To: T10 Technical Committee
From: John Worden (john.worden@seagate.com)
Date: 18 October 2002
Subject: 02-424r0 SAS Additional Port Layer Tweaks

This adds clarification and minor corrections to the SAS Port layer rewrite (02-393r1). Changes include:

Figure 2. Port layer Overall Control (PL_OC) state machine

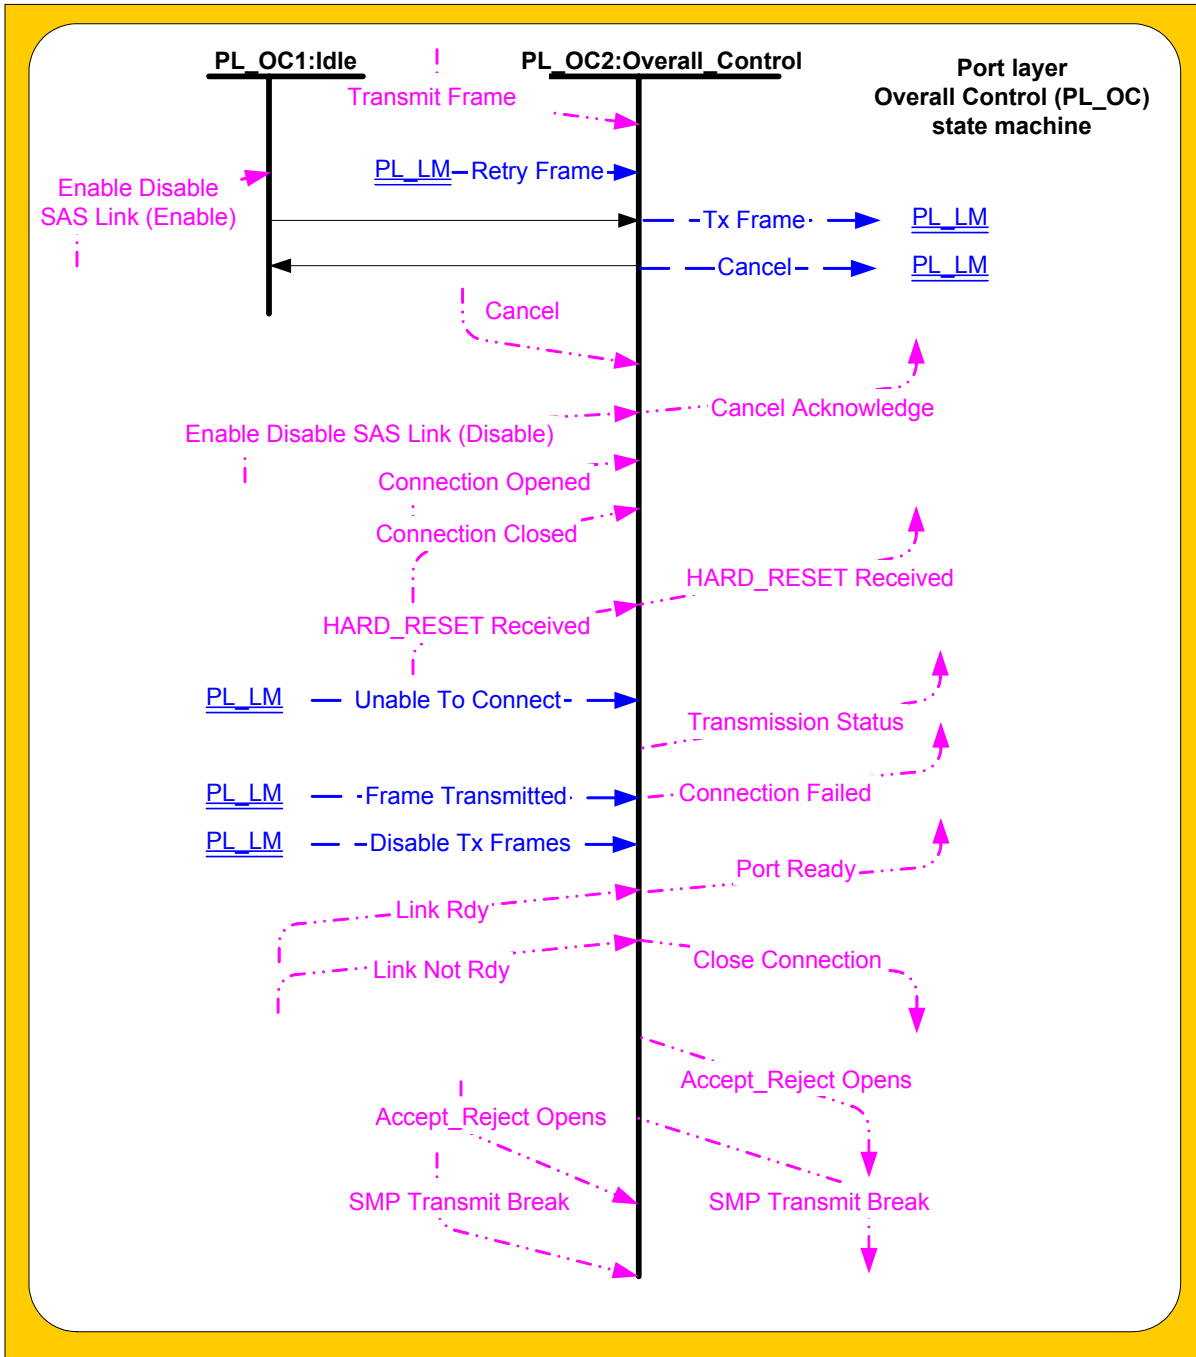
(Editors Note; Delete "Link Rdy " and "Link Not Rdy" from figure 2 ???)

Figure 3. Transmit Arguments

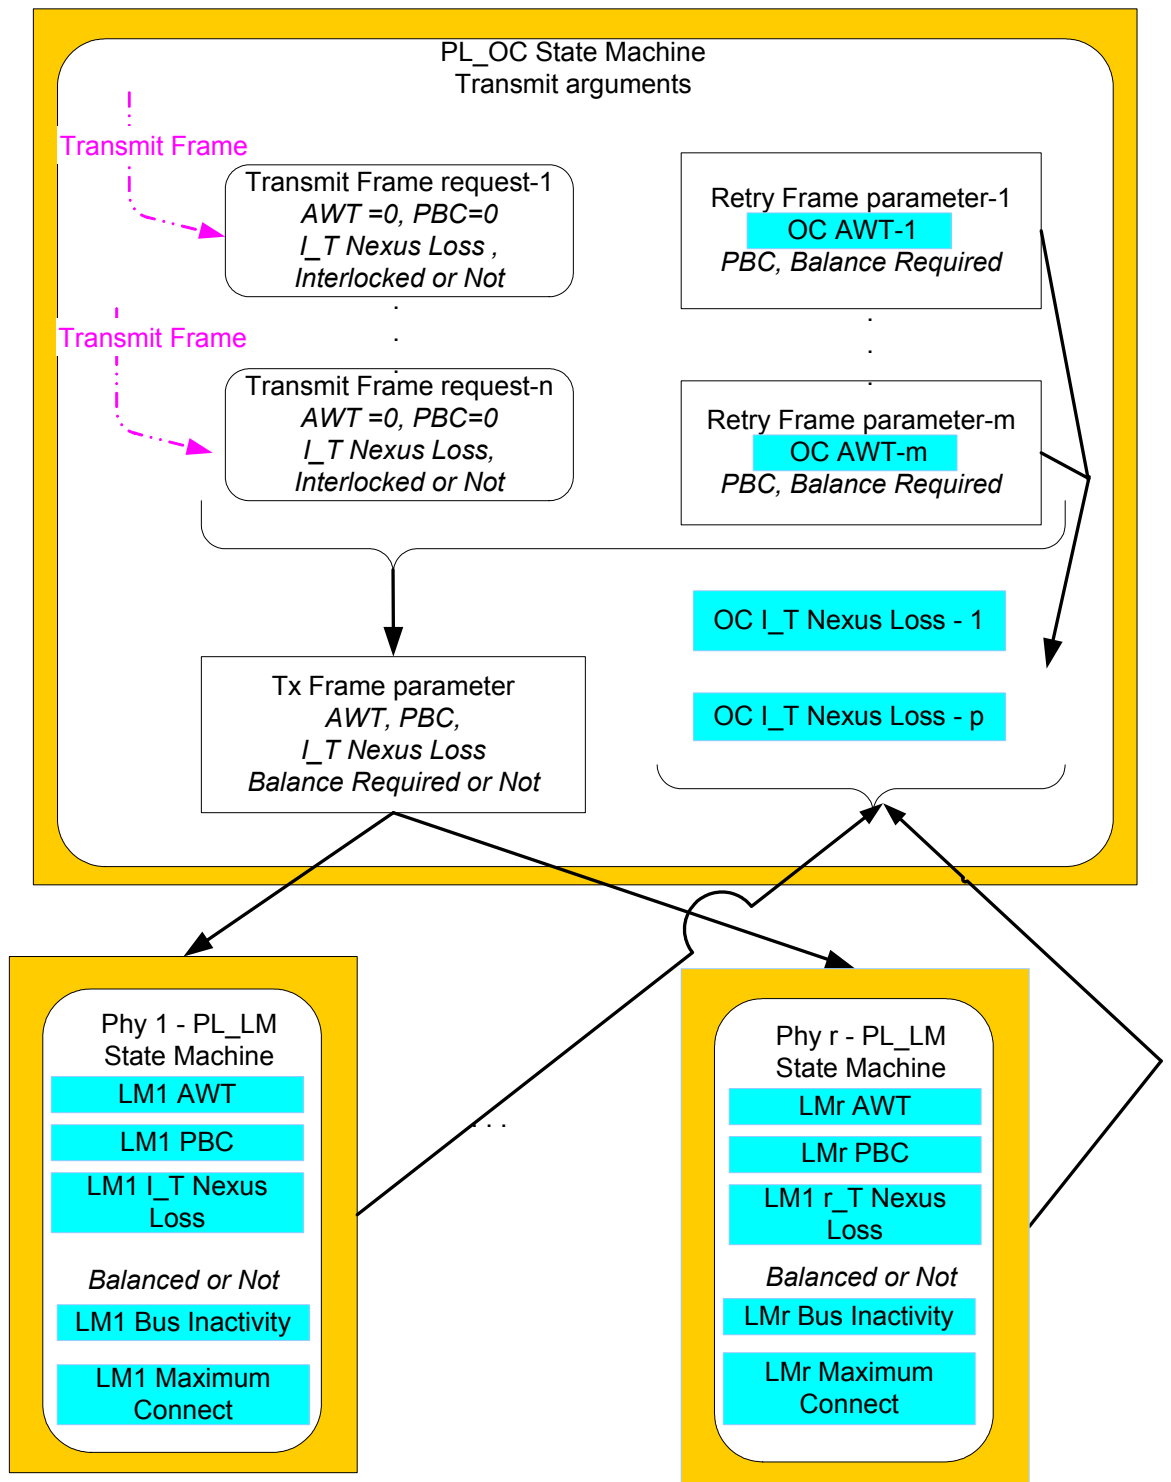
- a) Clarifies usage of the I_T nexus loss timer
- b) Adds the I_T nexus loss argument to the Transmit Frame request
- c) Adds Figure 3. Transmit Arguments plus explanatory text
- d) Minor technical corrections and other clarifications

This state shall send a Tx Frame parameter to the PL_LM state machine corresponding to the selected phy carrying all the arguments from the selected Transmit Frame request or Retry Frame parameter unless otherwise noted in this specification. Figure 3 identifies transmit arguments passed between the PL_OC and PL_LM state machines. In Figure 3, Requests are in rectangular boxes with rounded corners and parameters are in rectangular boxes with square corners. Arguments are either in italics or shaded with light blue if from/to a counter or timer. The AWT, PBC, I_T nexus loss arguments for the PL_OC Tx Frame parameter are transferred to the selected PL_LM's AWT timer, PBC counter, and I_T nexus loss timer respectively. The AWT and PBC arguments for Transmit Frame requests are implied to be zero and are not received as arguments with the Transmit Frame request from the transport layer. The AWT and PBC arguments for the PL_OC Retry Frame parameters are obtained from the appropriate PL_LM AWT timer or PBC counter. The PL_OC Retry Frame AWT argument is stored in a timer which shall start incrementing if the AWT value received from the PL_LM state machine is non zero. If the value received is zero, the PL_OC AWT timer shall not start incrementing. The PL_OC Retry Frame parameter shall include a Balanced Required argument. The I_T nexus loss argument for the Tx Frame parameter is either ;

- a) obtained from the Transmit Frame request I_T nexus loss argument for Transmit Frame requests;
or
- b) obtained from the OC I_T nexus loss timer if a non zero timer value exists for this destination for
Retry parameters; or
- c) set to zero if no non zero OC I_T nexus loss timer exists for this destination for Retry parameters.

The current PL_LM I_T nexus loss timer value for a Transmit Frame request is sent to the transport layer as an argument in any Open Failed Transmission Status confirmation. For each destination, an OC I_T nexus loss timer is created from any non zero PL_LM I_T nexus loss timer value when an Unable To Connect parameter is received from the PL_LM state machine. This OC I_T nexus loss timer shall start incrementing from this non zero value. If the PL_LM I_T nexus loss timer value is zero when an Unable To Connect parameter is received, any existing OC I_T nexus loss timer to this destination shall be stopped incrementing and reset to zero.
